UNITED STATES PATENT AND TRADEMARK OFFICE

APPLICATION NO.	FILING DATE	FIRST NAMED INVENTOR	ATTORNEY DOCKET NO.	CONFIRMATION NO.
09/982,801	10/22/2001	Johan Mercke	027557-072	8392

Office Action Summary

DETAILED ACTION

7. **Downs et al.** disclose a method and system for monitoring parameters of a rechargeable power supply. Fig. 1 of **Downs et al.** is reproduced below. From col. 2 of **Downs et al.**:

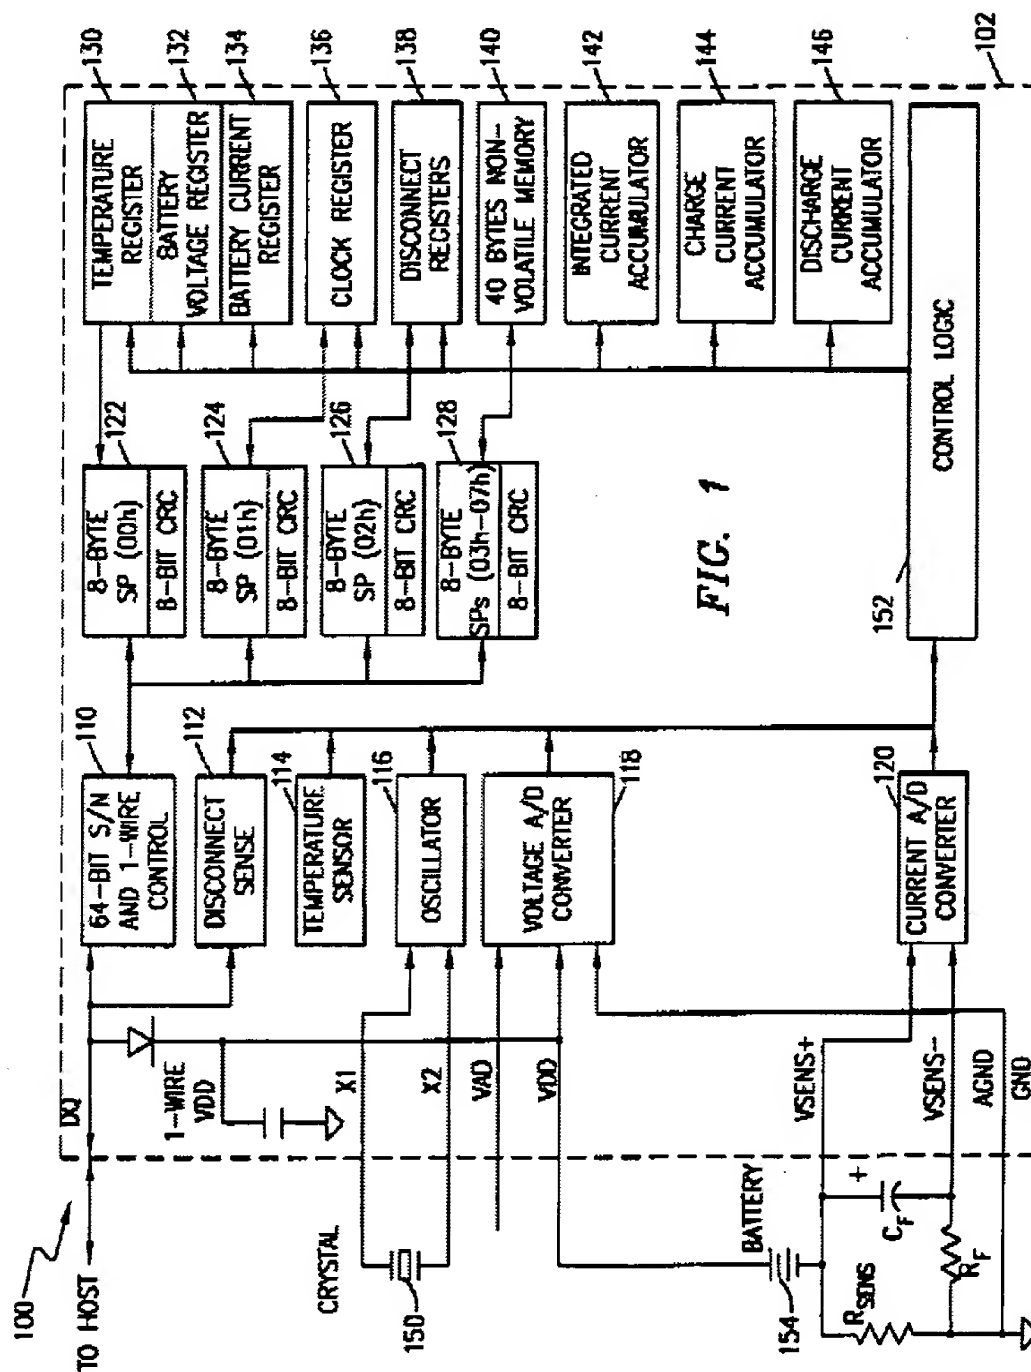
8. As per independent claims 1 and 24, and as can be seen from Fig. 1 reproduced above and its description by **Downs et al.**, we clearly see the claimed A/D, the logic unit, and the output register. The claimed processor is associated with the host of **Downs et al.**

9. As per dependent claims 38 and 46 which refer to a "digital signal stream", and the "logic unit adapted for updating the value of the or each parameter contained in the register as required in response to the digital signal stream", the Examiner interprets this as nothing more than overwriting a previously stored parameter with a newly acquired parameter in response to a clock signal or interrupt or other signal initiated by the control logic of **Downs et al.**
